**From:** [REDACTED]  
**Sent:** 21/02/2024 12:11:41 PM  
**To:** Council Northernbeaches Mailbox  
**Cc:** Mia  
**Subject:** DA2024/0044 25 Kevin Avenue AVALON BEACH NSW 2107  
**Attachments:** 25 KEVIN WS.pdf;

# SUBMISSION

RE: DA 2024 0044  
25-27 KEVIN AVENUE, AVALON BEACH NSW 2107  
WRITTEN SUBMISSION: LETTER OF OBJECTION  
SUBMISSION: TULLOCH

Footpath access to Bus Stops, to shops and services

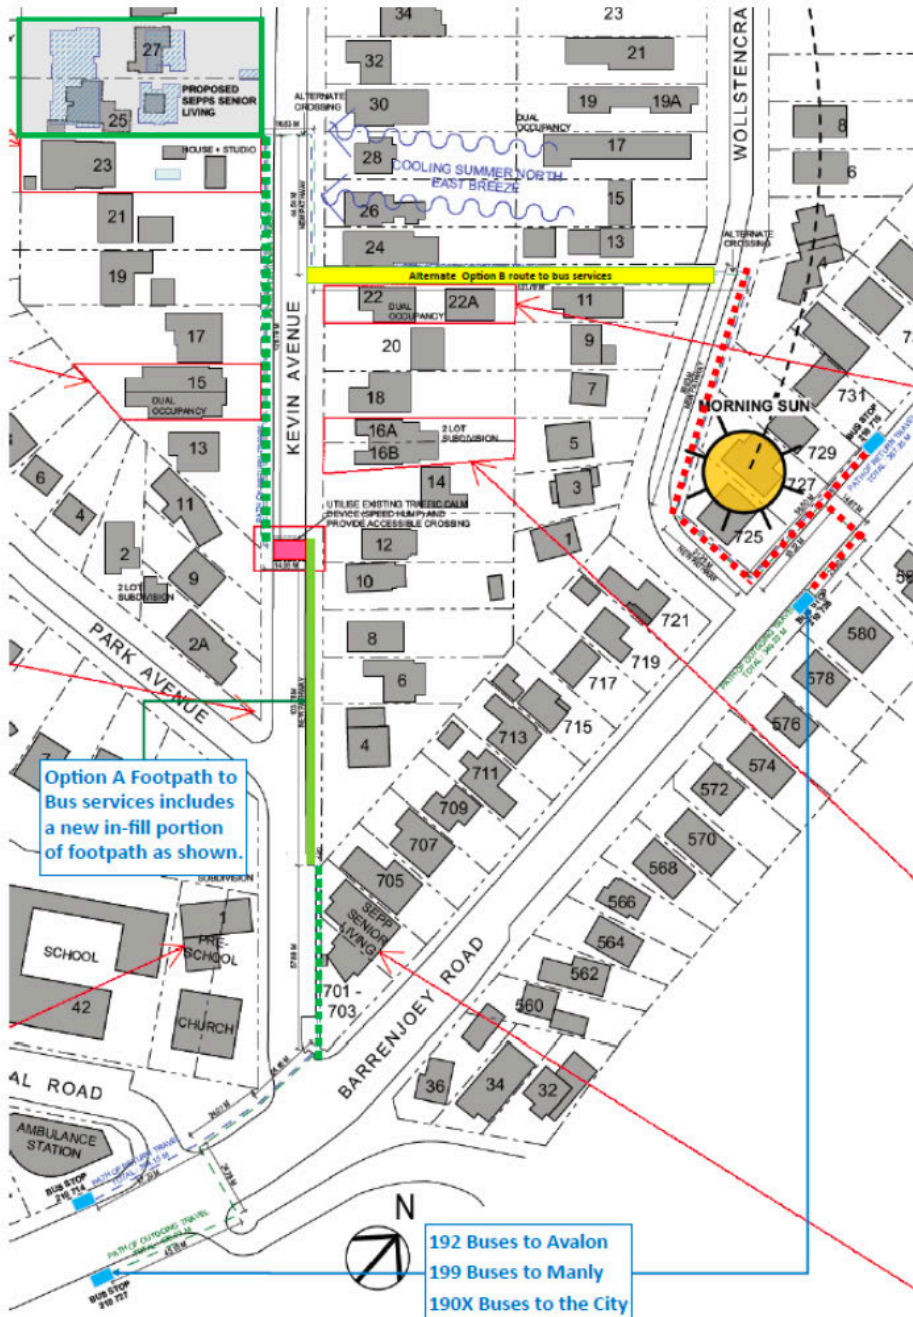
The applicant has not provided adequate survey or design to show how access to the bus stops will be achieved to satisfy this very important clause in the SEPP.

The simple line drawing provided, would appear:

- To be in excess of 400m;
- Transverse land zones that exceed 1:14 in slope;
- The gradient at the end of Kevin Avenue where it meets Barrenjoey Road is significantly steeper than the 1:14 slope specified in SEPP and would not be suitable for wheel chair users, particularly if this was a part of a significant 400m journey for wheel chair users;
- Requires removal of significant trees and landscaping in the Council reserve, including the large native tree between 28 Kevin Avenue & 30 Kevin Avenue;
- Cuts through power pole locations;
- Places pedestrian crossings adjacent to or across existing driveways
